161 Hicks St

**City of Portland, Maine - Building or Use Permit Application**  
 389 Congress Street, 04101 Tel: (207) 874-8703, FAX: (207) 8716

Job No: 2011-07-1693-NEWCOM	Date Applied: 7/13/2011	CBL: 297 - - C - 033 - 001 - - - - -
Location of Construction: 161 HICKS STREET	Owner Name: MOUNT SINAI CEMETERY ASSOC	Owner Address: 185 HICKS ST PORTLAND, ME - MAINE 04103
Business Name:	Contractor Name: Arte Garland	Contractor Address: PO Box 1204, Gray, ME 04039
Lessee/Buyer's Name:	Phone:	Permit Type: <b>EXPIRED</b>
Past Use: Cemetary	Proposed Use: Same: Cemetary - to add a detached 20'x24' equipment shed	Cost of Work: \$20,000.00
	Fire Dept: <input type="checkbox"/> Approved <input type="checkbox"/> Denied <input type="checkbox"/> N/A	Zone: R-3
Proposed Project Description: build 20 x 24 equipment building		Inspection: Use Group: Type: Signature:
Permit Taken By: Lannie	Pedestrian Activities District (P.A.D.)

20'x24' EQUIPMENT SHED  
 MOUNT SIANI CEMETARY  
 HICKS ST.  
 PORTLAND, MAINE

MAP 297-C-36  
PLOT PLAN  
MT. SINAI CEMETERY  
HICKS STREET  
PORTLAND, MAINE  
MAP 297 C.35 #36

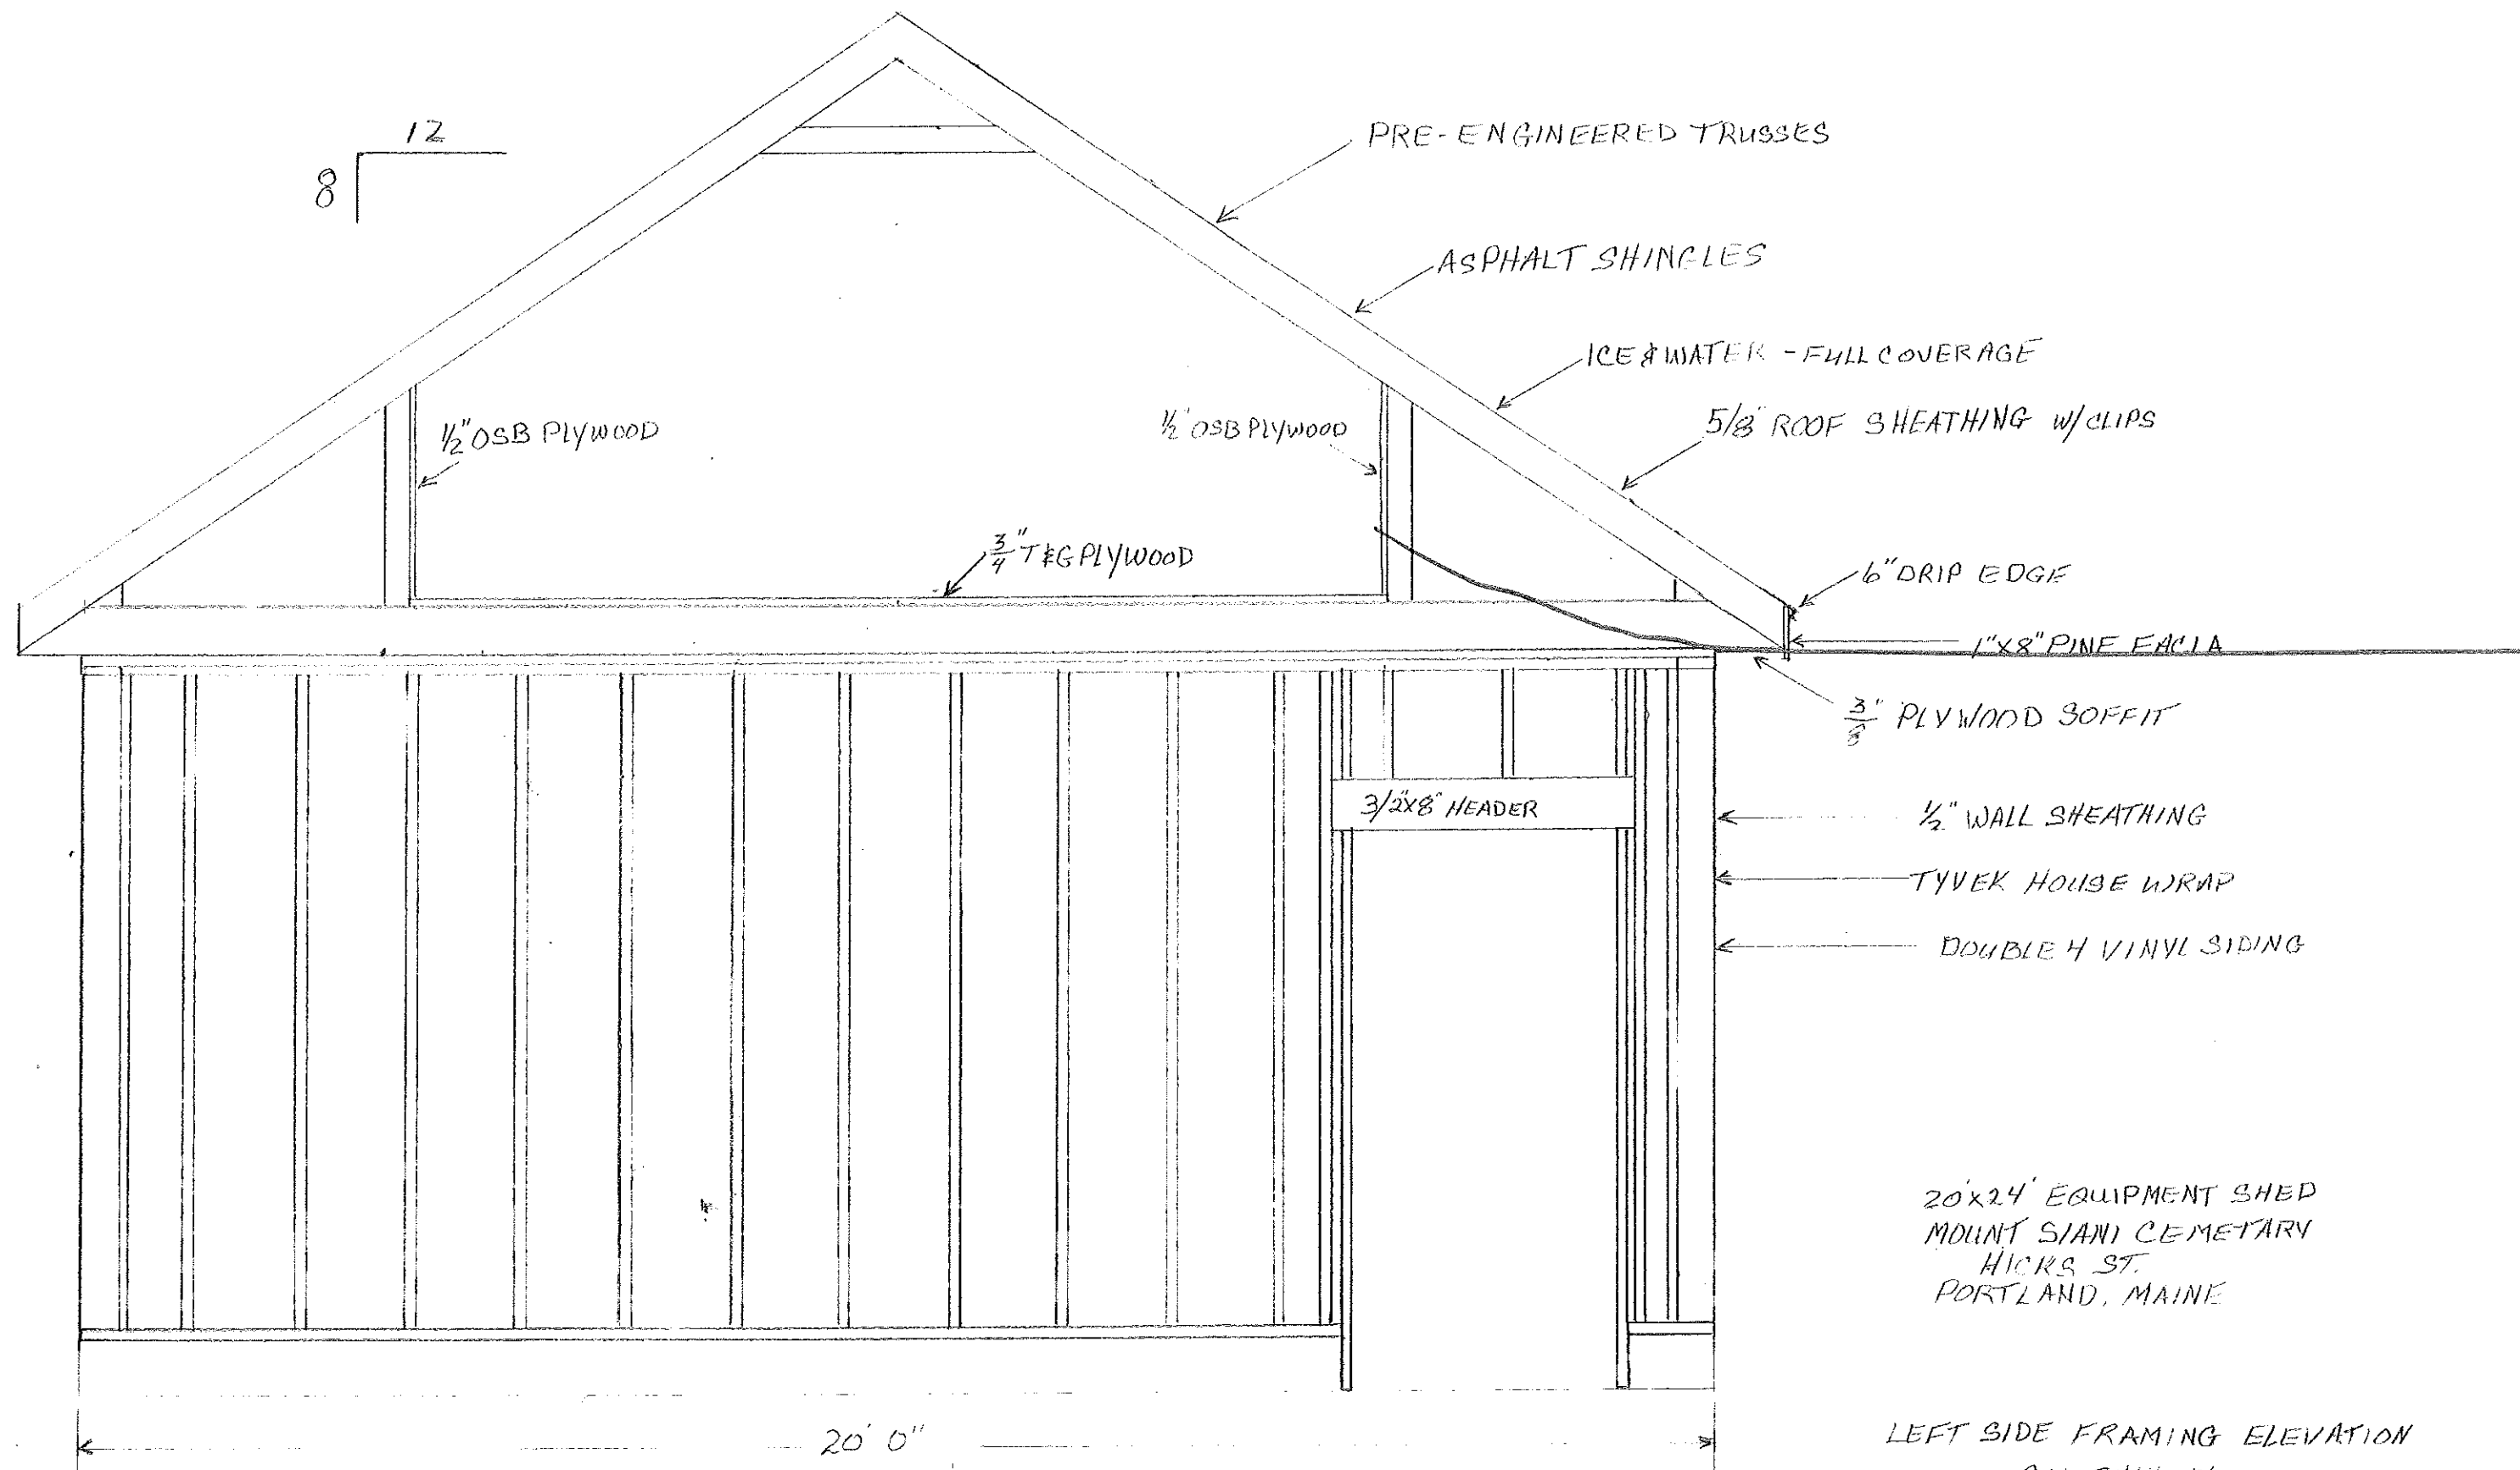
1. This property is located in an R-3 Residential Zone where a 25' rear setback is required. The plot plan shows 7' at the closest – I will contact the contractor – permit on hold – I will distribute the Administrative Authorization to the Planning Division – MES
2. 7/5/2012 this permit has expired – over 6 months old – I never received the information that the contractor said he would get to me - MES
